**DEPARTMENT OF TRANSPORTATION**

Office of Structural Materials

Contract #: 04-0120F4Cty: SF/ALA Rte: 80 PM: 13.2/13.9File #: 69.28**WELDING INSPECTION REPORT****Resident Engineer:** Siegenthaler, Peter**Address:** 333 Burma Road**City:** Oakland, CA 94607**Report No:** WIR-018337**Date Inspected:** 17-Nov-2010**Project Name:** SAS Superstructure**OSM Arrival Time:** 700**Prime Contractor:** American Bridge/Fluor Enterprises, a JV**OSM Departure Time:** 1900**Contractor:** Zhenhua Port Machinery Company, Ltd (ZPMC), Changxing Island **Location:** Shanghai, China**CWI Name:** Xu Le Feng, Geng Wei**CWI Present:** Yes No**Inspected CWI report:** Yes No N/A**Rod Oven in Use:** Yes No N/A**Electrode to specification:** Yes No N/A**Weld Procedures Followed:** Yes No N/A**Qualified Welders:** Yes No N/A**Verified Joint Fit-up:** Yes No N/A**Approved Drawings:** Yes No N/A**Approved WPS:** Yes No N/A**Delayed / Cancelled:** Yes No N/A**Bridge No:** 34-0006**Component:** OBG/TOWER**Summary of Items Observed:**

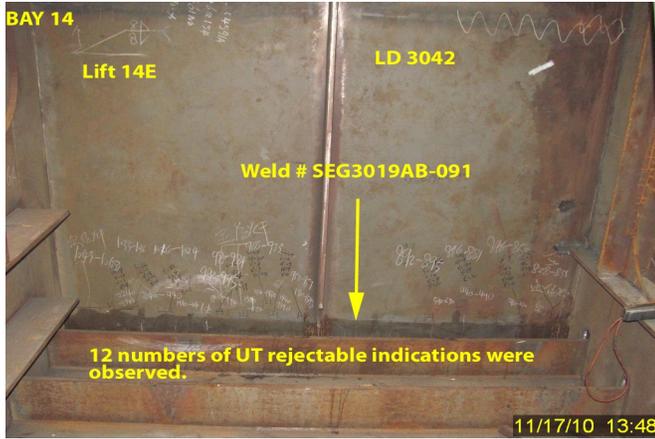
During random in process inspection this QA inspector recorded the data of repair weld joints. The Ultrasonic Testing (UT) performed by ZPMC NDT personnel on Complete Joint Penetration (CJP) weld joints of Longitudinal Diaphragm (LD3042) to Bottom plate of lift 14 and founds numbers of non conforming UT indications. Those indications were clearly marked on the weld joints. The details are as follows:

Weld joint # SEG3019AB-091, 12 nos of UT rejectable indications were observed with cumulative length 460mm. Attached photograph provides additional information.
